S/N: 10/599,571  
Reply to Office Action of October 1, 2009

Atty Dkt No. JANS0101PUSA

### **Remarks**

The following picture below shows an example of ligament flow from a flow module as described in the application.

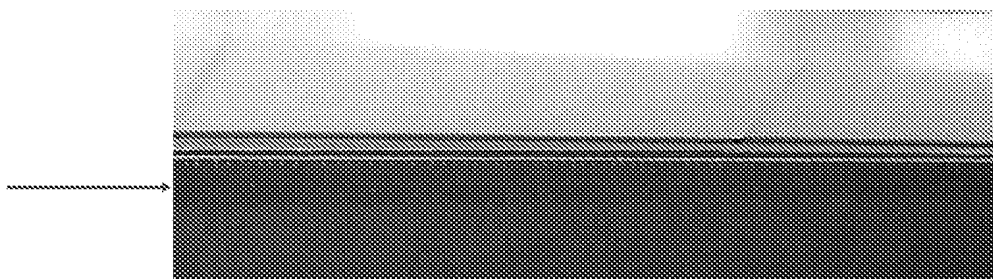
Claim 20 as amended requires "the spray system with flow distribution modules is illuminated in the area on the lips where ligament flow occurs during spraying, and a vision system is used to count the ligaments." (emphasis added). The Examiner states that "the use of a camera to analyze the flow from an electrospray apparatus is known in the art, as exemplified by MILLER, which discloses an electrospray apparatus (2) with a window (42) and an optical sensor (5) for generating and image of the spray". (Page 13 of the Office Action of October 1, 2009).

Miller et al. teaches a system having a camera 50 positioned in close proximity to an atomized plume of an individual nozzle ("the viewing orifice 46 is positioned . . . about 20 to 50 millimeters from the axis of the atomized plume. (Miller et al., Col. 4, lines 20-24). Placing a camera 20-50 mm from a high voltage source (40-65kV in Wichmann, Col. 10, lines 7-24) is not recommended due to arcing. The combination of Wichmann and Miller et al. does not teach or suggest a vision system for counting ligaments, and claim 20 is nonobvious over the Examiner's combination.
